BV2.5 (M2.5-Note) SYSTEM BLOCK DIAGRAM

SIT-->SVT REV : 3B
2006-07-24

PROJECT : BV2A
Quanta Computer Inc.

BV2A / M2.5-Note Schematic EC Tracking Record A (for SDV) Feb. 22, 2006**EC #/Page/Description/Part Affected/CMVC #**

VCCCPUCORE DECOUPLING

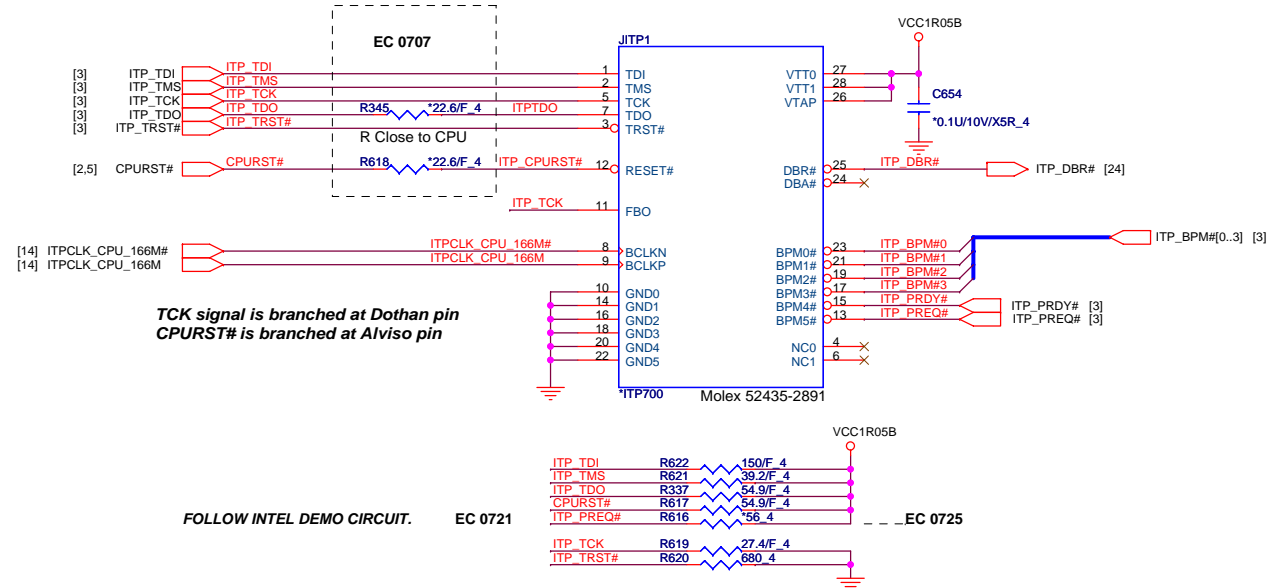
EC A-18 22UF 6.3V X5R 2125(0805) 1/16W X16 PCS
 10UF 6.3V X5R 2125(0805) X16 PCS

EC A-17 /67/	Delete description "NOASM" to avoid confusion	(SDV-Lenovo-019)
EC A-18 /03/	Change 16pcs of capacitors at CPU DC/DC : 22uF -> 10uF	(SDV-Lenovo-020)

EC A15

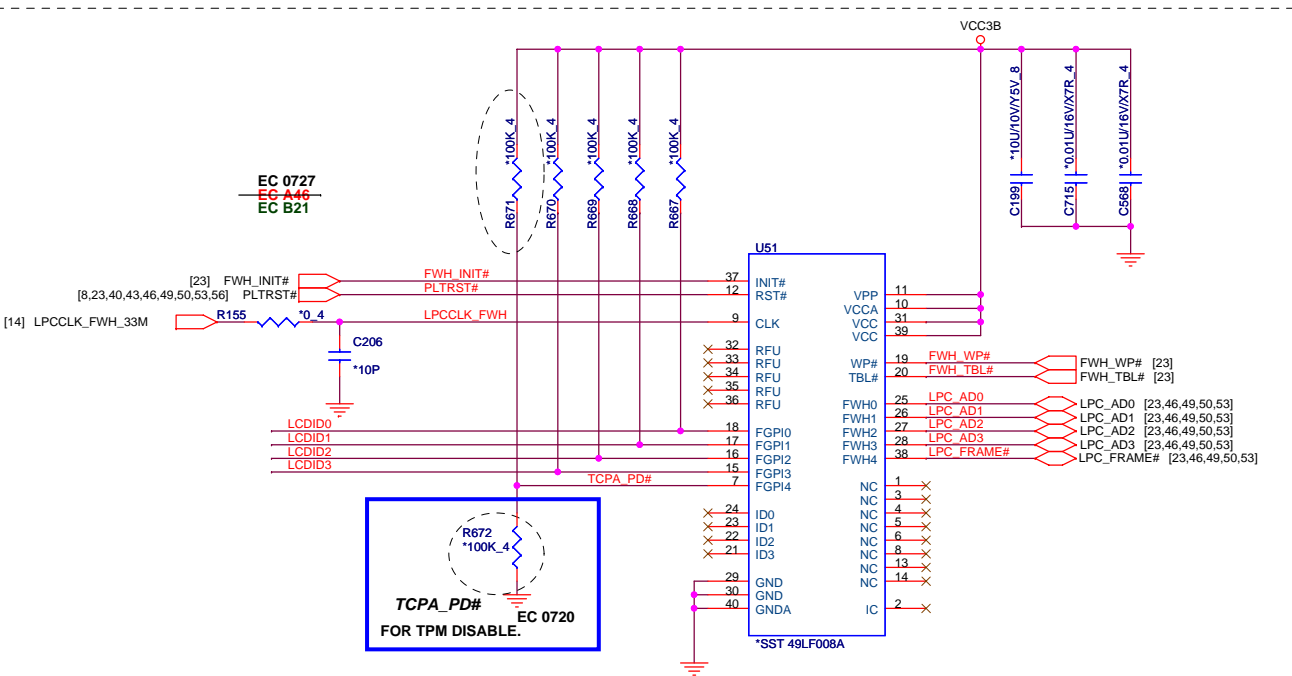
Remove 0ohm jumper for
VCC1R05B_ICH,
VCC1R5B_USB,
VCC1R5B_SATA

FWH change to co-layout TSSOP40 & PLCC32 type

EC 0720 JUST FOR DEBUG AND SMT 5PCS.
EC A43 Delete PLCC socket

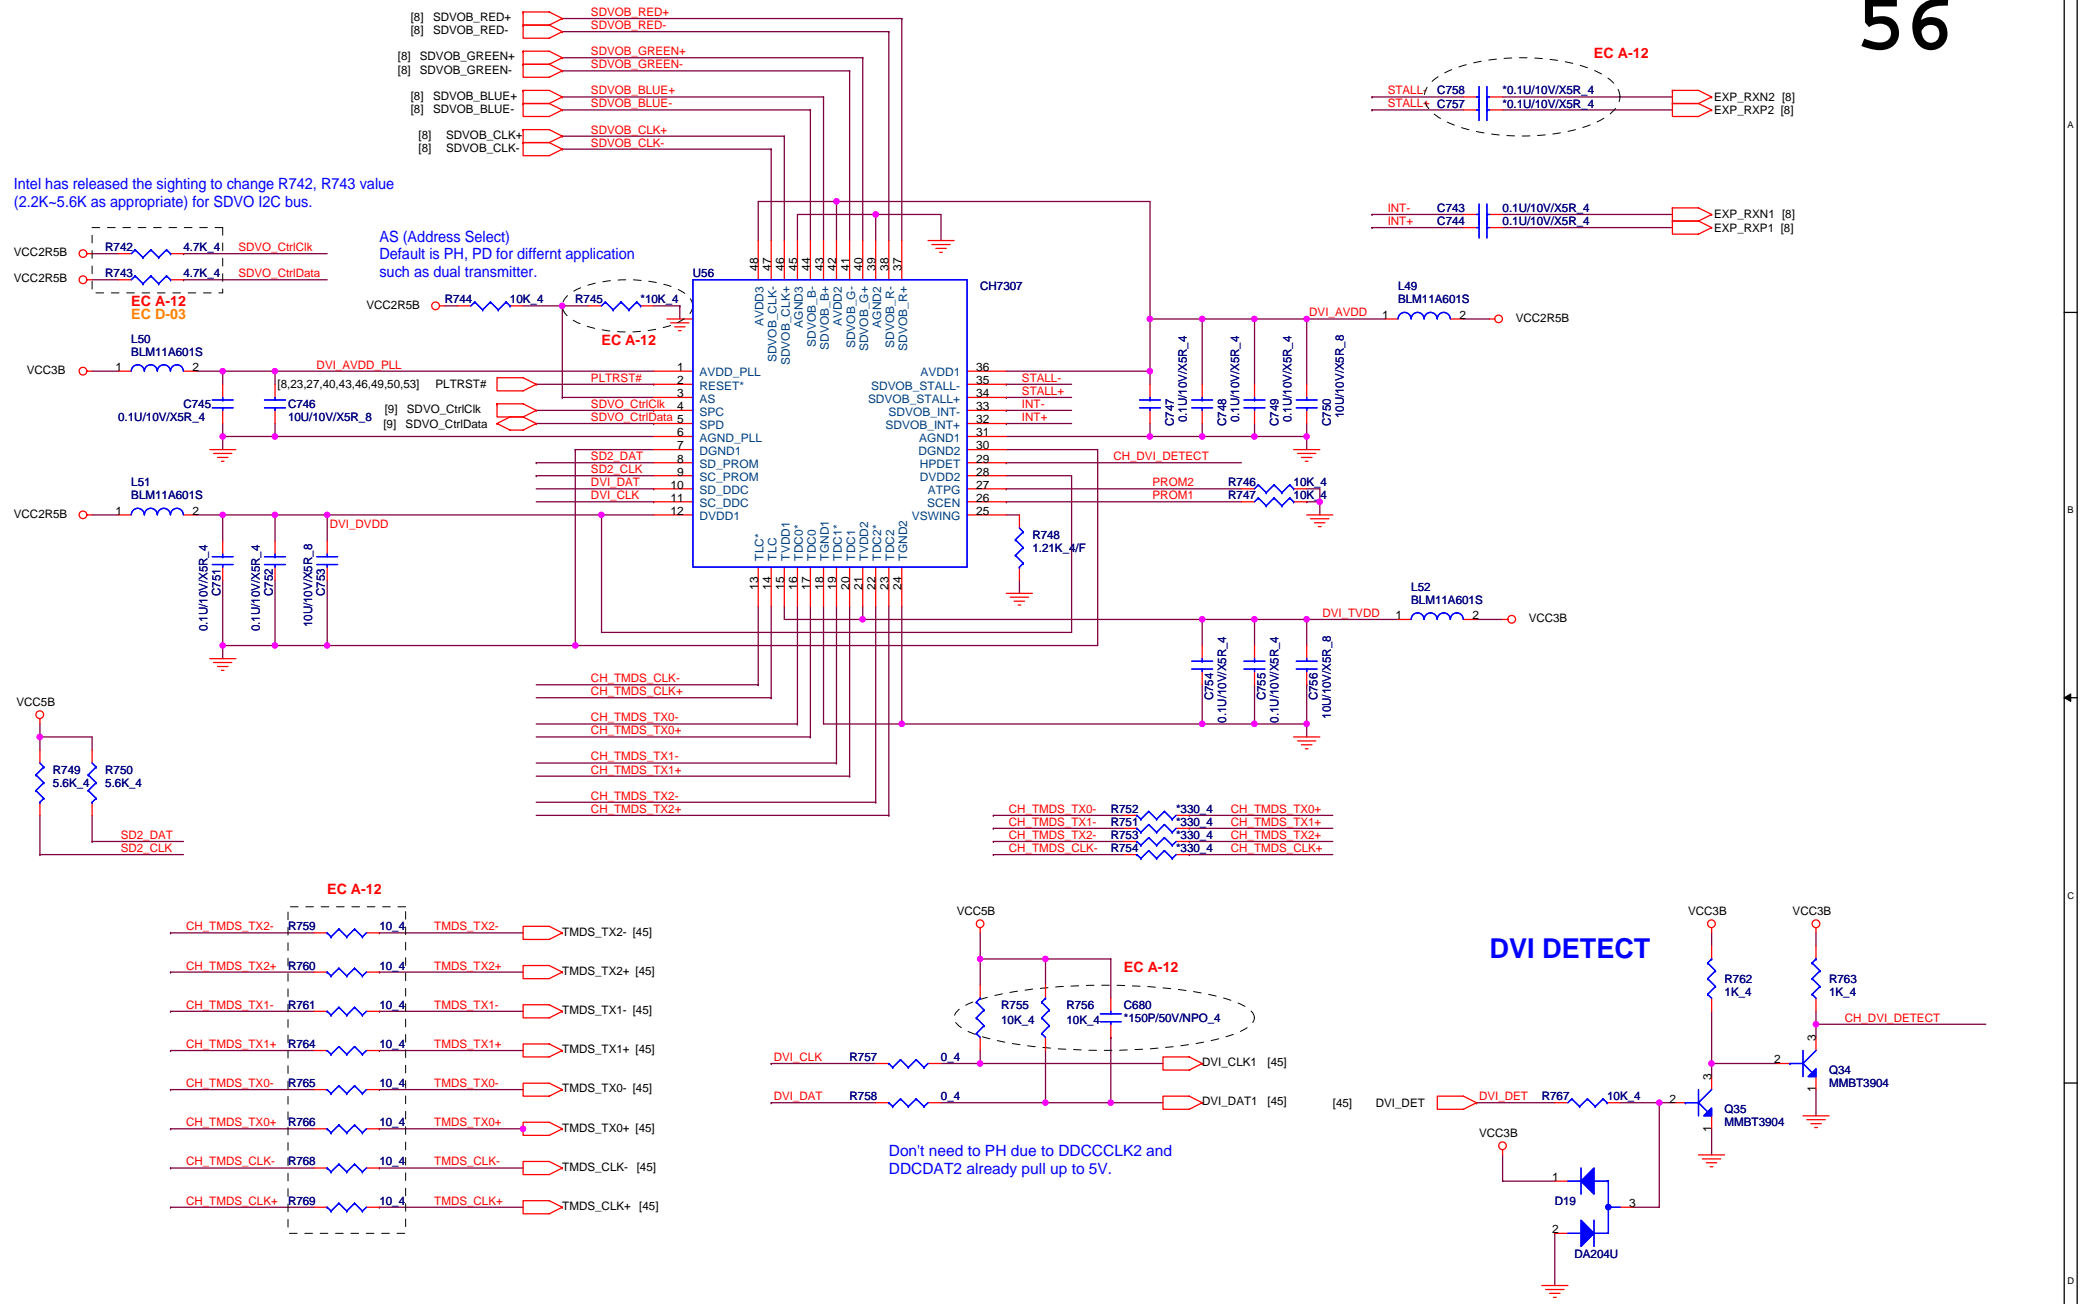
Intel has released the sighting to change R742, R743 value (2.2K-5.6K as appropriate) for SDVO I2C bus.

EC D-01 /24/	Change planar ID to 1000B	(SVT-Lenovo-001)
EC D-02 /70/	Del PD6, add R230 0 ohm and PC10 No-ASM	(SVT-Lenovo-002)
EC D-03 /56/	Change R742/R743 from 2.2K to 4.7K ohm for DVI device detect issue	(SVT-Lenovo-003)
